**Recommended Amendments to the  
2015 International Residential Code**  
North Central Texas Council of Governments Region

The following sections, paragraphs, and sentences of the *2012 International Residential Code* are hereby amended as follows: Standard type is text from the IRC. Underlined type is text inserted. ~~Lined through type~~ is deleted text from IRC. A double asterisk at the beginning of a section identifies an amendment carried over from the 2012 edition of the code and a triple asterisk identifies a new or revised amendment with the 2015 code.

**\*\*Figure R602.6.1; delete the figure and insert the following figure:**

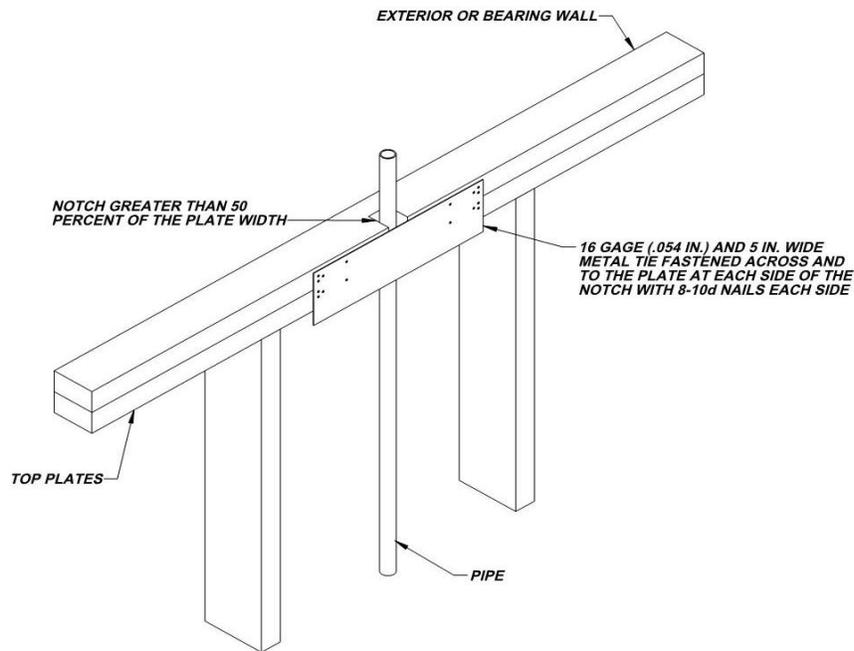
**R602.6.1 Drilling and notching of top plate.** When piping or ductwork is placed in or partly in an exterior wall or interior load-bearing wall, necessitating cutting, drilling or notching of the top plate by more than 50 percent of its width, a galvanized metal tie not less than 0.054 inch thick (1.37 mm) (16 Ga) and ~~4 ½ inches (38 mm)~~ 5 inches (127 mm) wide shall be fastened across and to the plate at each side of the opening with not less than eight 10d (0.148 inch diameter) having a minimum length of 1 ½ inches (38 mm) at each side or equivalent. Fasteners will be offset to prevent splitting of the top plate material. The metal tie must extend a minimum of 6 inches past the opening. See figure R602.6.1. {remainder unchanged}

*(Amendment to 2012 IRC carried forward to 2015 IRC also provides additional assurance of maintaining the integrity of the framing by spreading the nailing pattern.)*
